**AOS SPACE DATA
LINK PROTOCOL**

CCSDS 732.0-B-1.3

PINK SHEETS

September 2005

Figure 4-2: Transfer Frame Primary Header

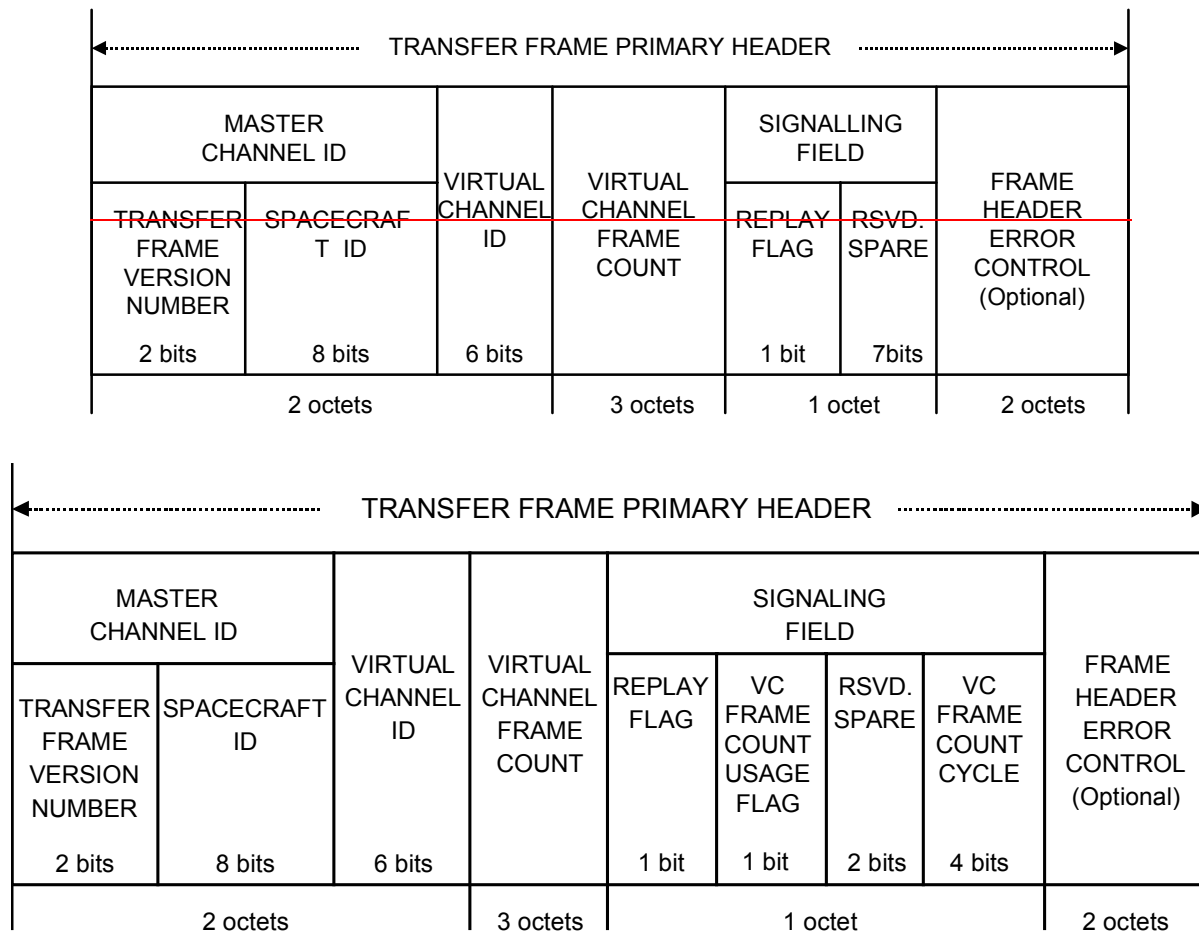
4.1.2.5.1.3 This 8-bit field shall be subdivided into ~~two~~four sub-fields as follows:

- a) Replay Flag (1 bit, mandatory);
- ~~b) Reserved Spares (7 bit, mandatory);~~
- b) Virtual Channel (VC) Frame Count Cycle Use Flag (1 bit, mandatory);
- c) Reserved Spares (2 bits, mandatory);
- d) Virtual Channel Frame Count Cycle (4 bits, optional).

~~4.1.2.5.3 Reserved Spare~~

~~4.1.2.5.3.1 Bits 41-47 of the Transfer Frame Primary Header shall contain Reserved Spare.~~

~~4.1.2.5.3.2 This seven-bit Reserved Spare field shall be reserved by CCSDS for potential future signaling applications and in the interim shall, by convention, be set to the value 'all zeros'.~~

4.1.2.5.3 Virtual Channel (VC) Frame Count Cycle Use Flag

4.1.2.5.3.1 Bit 41 of the Transfer Frame Primary Header shall contain the VC Frame Count Cycle Use Flag.

4.1.2.5.3.2 This one-bit field shall indicate whether the VC Frame Count Cycle field is used; its value shall be interpreted as follows:

- a) '0' = VC Frame Count Cycle field is not used and shall be ignored by the receiver;
- b) '1' = VC Frame Count Cycle field is used and shall be interpreted by the receiver.

4.1.2.5.4 Reserved Spare

4.1.2.5.4.1 Bits 42-43 of the Transfer Frame Primary Header shall contain the reserved spare.

4.1.2.5.4.2 This 2-bit field is reserved for future definition by CCSDS and shall be set to '00'.

4.1.2.5.5 Virtual Channel (VC) Frame Count Cycle

4.1.2.5.5.1 If used, bits 44-47 of the Transfer Frame Primary Header shall contain the Virtual Channel Frame Count Cycle field.

4.1.2.5.5.2 Each time the Virtual Channel Frame Count returns to zero, the VC Frame Count Cycle shall be incremented.

NOTE – The VC Frame Count Cycle effectively extends the Virtual Channel Frame Count from 24 to 28 bits.

4.1.2.5.5.3 If not used, bits 44 through 47 of the Transfer Frame Primary Header shall be set to 'all zeros'.
